**HARTZELL PROPELLER INC.**  
**ALERT SERVICE BULLETIN**  
**TRANSMITTAL SHEET**  
**HC-ASB-61-396**  
**Raptor Hub Units - Shot Peening**

March 09, 2022

This page transmits a revision to Alert Service Bulletin HC-ASB-61-396.

Revision 1 is issued to change the following in the Alert Service Bulletin:

**Stamping the Hub**  
**Figure 1**

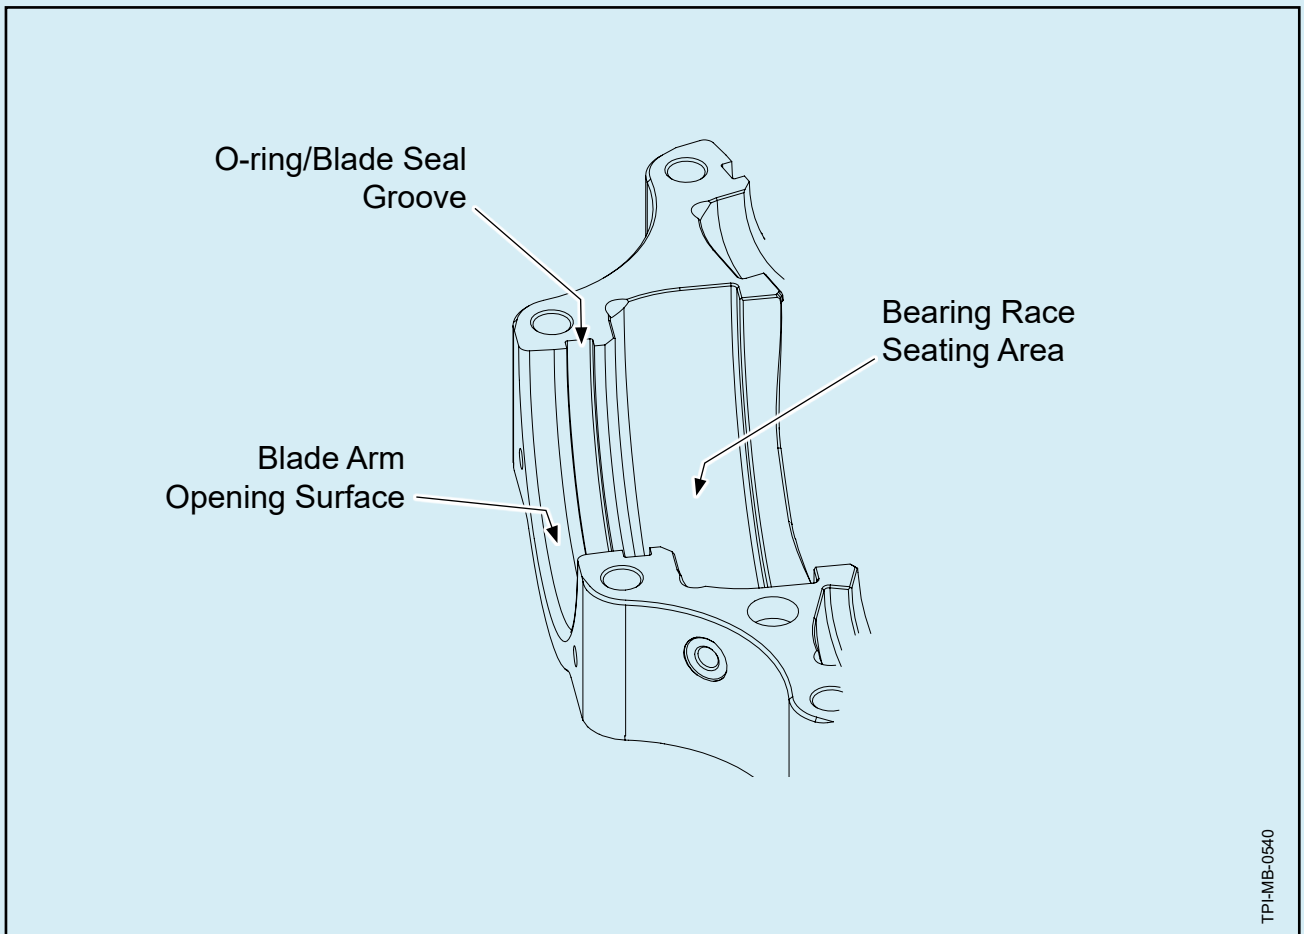
- Revise the instructions for impression stamping the shot peened hub in the "Accomplishment Instructions" section

CAUTION: IN THE FOLLOWING STEP, IMPRESSION STAMP THE HUB ABOVE/BELOW THE HUB SERIAL NUMBER, NOT THE PROPELLER SERIAL NUMBER.

- (a) Impression stamp "SP" above or below the hub serial number on the cylinder-side hub half as shown in Figure 1.

NOTE: The "SP" stamp indicates the hub unit was shot peened in accordance with this Alert Service Bulletin.

**Bearing Arm Opening Surface**  
**Figure 2**

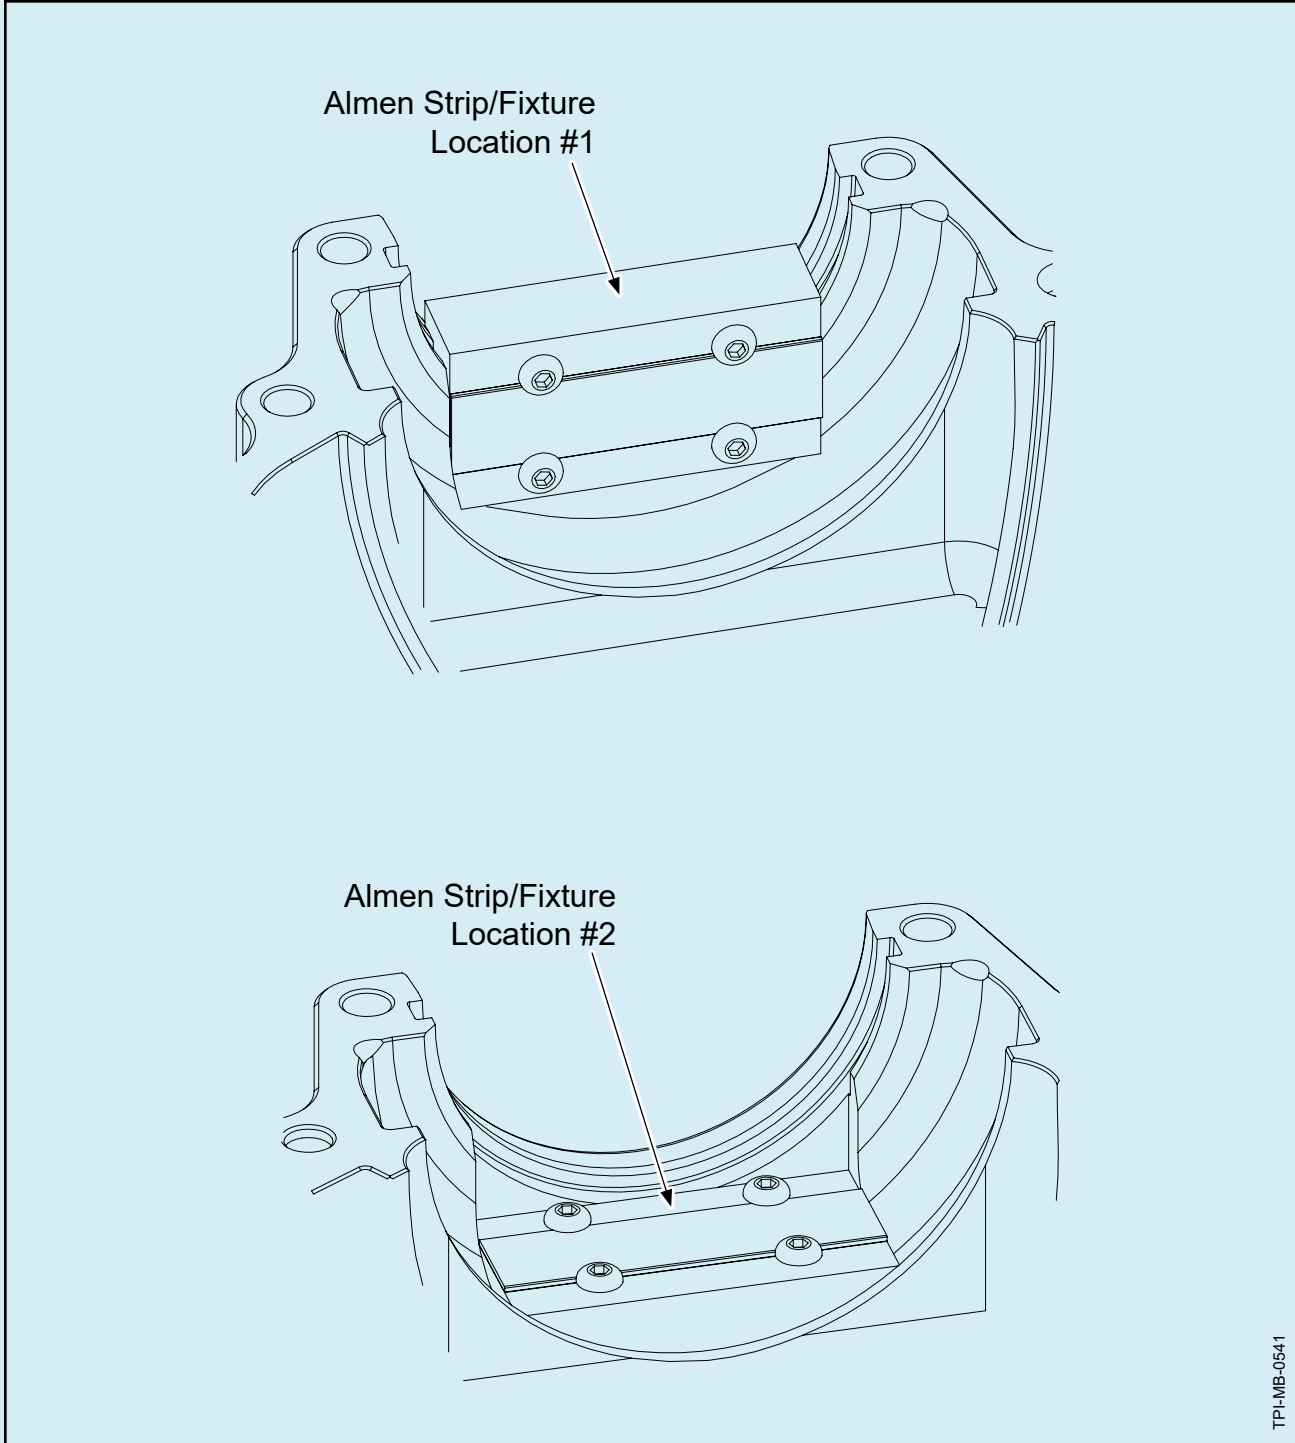
- (1) Hartzell Propeller Inc. has received reports of insufficient shot peen coverage in the bearing race seating area of the hub unit on affected propellers. Refer to Figure 2.

- (1) Mask the internal surfaces of the hub in accordance with the Aluminum Hub Overhaul chapter of Hartzell Propeller Inc. Standard Practices Manual 202A (61-01-02).
  - (a) Additionally, mask the blade arm opening surface outboard of the O-ring/blade seal groove. Refer to Figure 2.
